***Re: Groundwater Sustainability Plans for the Oxnard Subbasin and Pleasant Valley Basin***

**Technical Analysis of  
Groundwater Sustainability Plans for the Oxnard Plain and  
Pleasant Valley Subbasins, July 2019**

**Steven Bachman, PhD  
September, 2019**

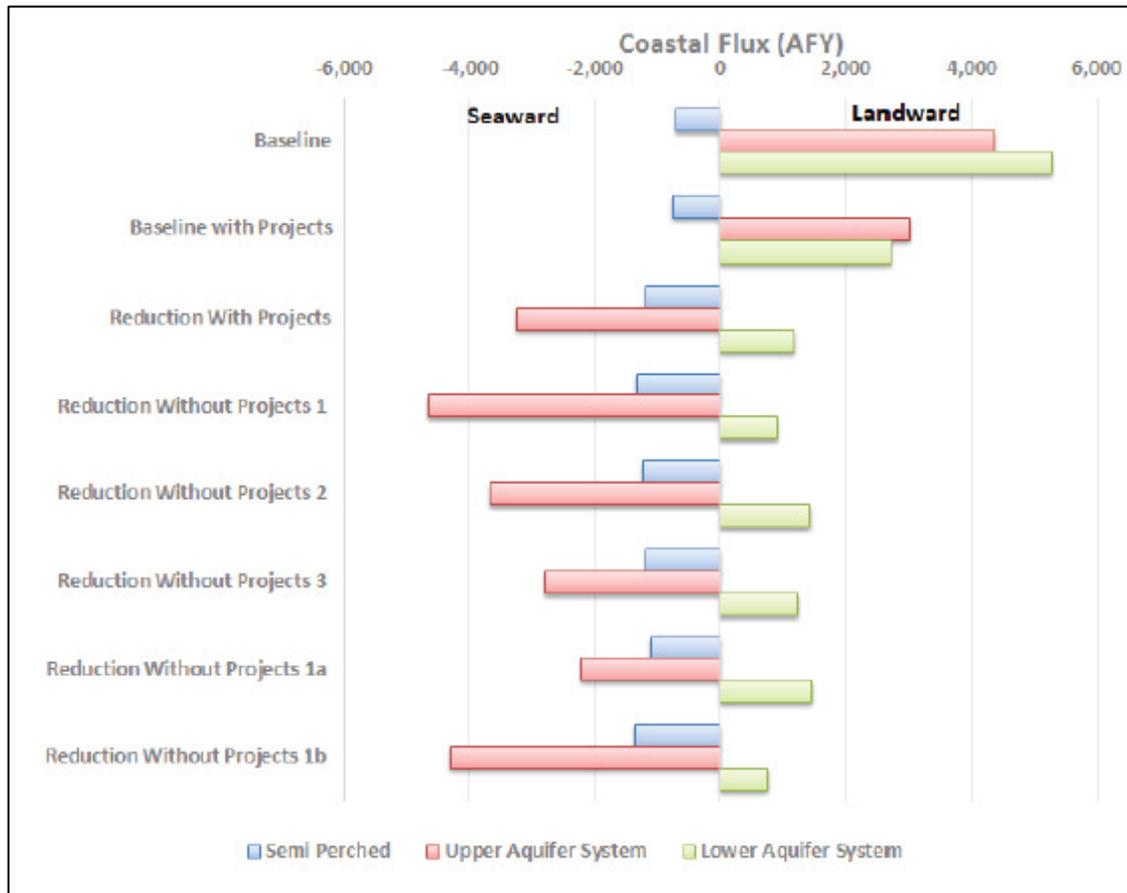
3. Model simulations to determine sustainability have not been optimized, with GSP simulations indicating an average of thousands of acre-feet per year of discharge of fresh water into the ocean: The GSPs considered a few solutions with varying selected projects and pumping reductions. These include use of recycled water and fallowing of agricultural fields. However, there apparently was not an attempt to optimize these projects and pumping reductions that would result in both no net seawater intrusion and no net fresh groundwater lost to the ocean. In fact, as illustrated below (Figure 1), the solutions resulted in continued seawater intrusion in the Lower Aquifer at the same time that there were thousands of acre-feet per year of fresh water discharged into the ocean. Seawater intrusion is not solved for the Lower Aquifer.

The solutions on which GSP results and sustainability criteria are based do not solve the seawater problem, as long as there continues to be seawater intrusion in the Lower Aquifer. These solutions are not sustainable because undesirable results continue to occur in the subbasins. It is thus not possible to determine the sustainable yield of the subbasins when none of the model runs prevent seawater intrusion.

Figure 2. GSP sustainability criteria shown at USGS inland well 20J8 (Oxnard Plain GSP, Figure 3-6a). The left of the chart are measured data, the right indicates modeled data. The lower horizontal line is the Minimum Threshold, the upper horizontal line is the Measurable Objective.

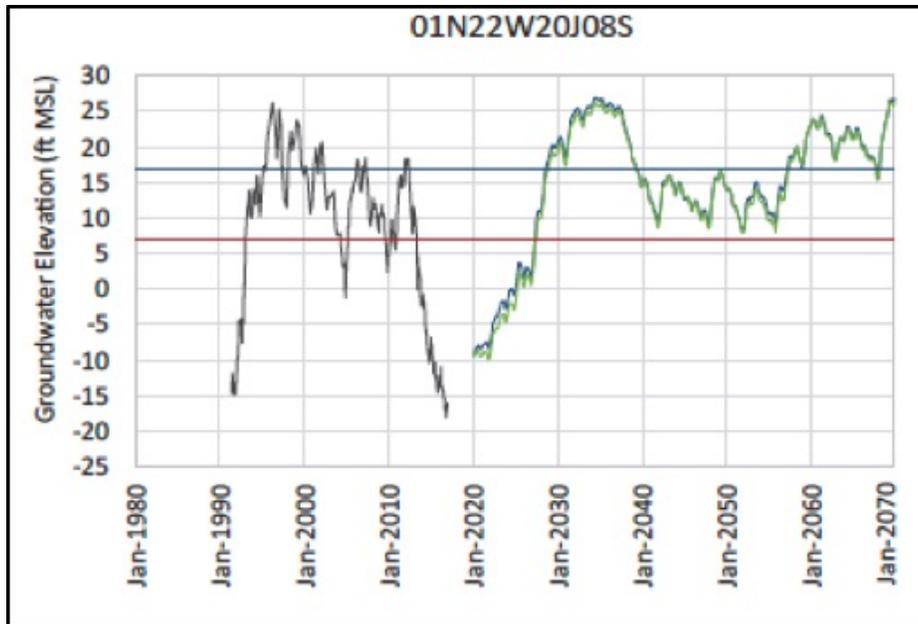
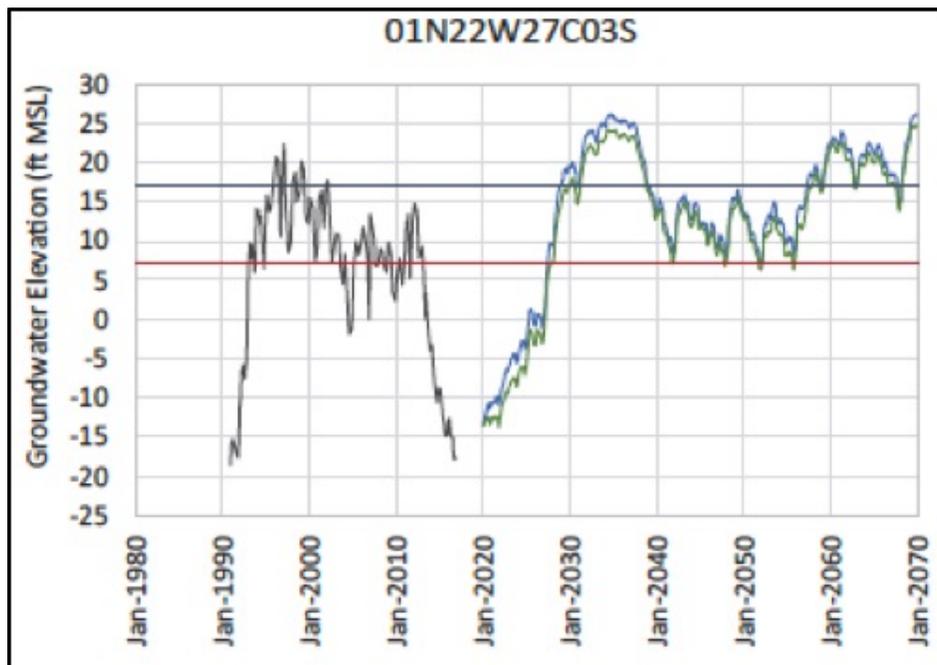
Other good examples of successful strategies to prevent seawater intrusion are in Orange and LA counties. Injection barriers in those coastal locations prevent seawater intrusion and meet the criteria of coastal groundwater elevations somewhat above sea level. However, interior areas landward of the coast may have groundwater elevations below sea level, as long as coastal groundwater elevations are maintained. Both Figure 2 and Figure 3 are in inland areas of the Oxnard Plain, where groundwater elevations could potentially be much lower with the right projects. Thus, these inland areas are not the correct location to have sustainability criteria for seawater intrusion.

The GSPs should be modified to substitute coastal groundwater elevations that prevent landward movement of seawater for Measurable Objectives and eliminate those inland Objectives that are currently based on incomplete modeling results that did not solve future seawater intrusion. Pumping should be varied by wet, normal, and dry years and Minimum Thresholds should be set accordingly. As required in the DWR BMPs, a chloride isochore should be the Minimum Threshold near the front of the current seawater intrusion. Modeling should only be used to examine the effectiveness of future management strategies in meeting sustainability criteria, and a larger list of management strategies should be used (including those modeled by United Water). Pumping should be varied by wet, average, and dry years
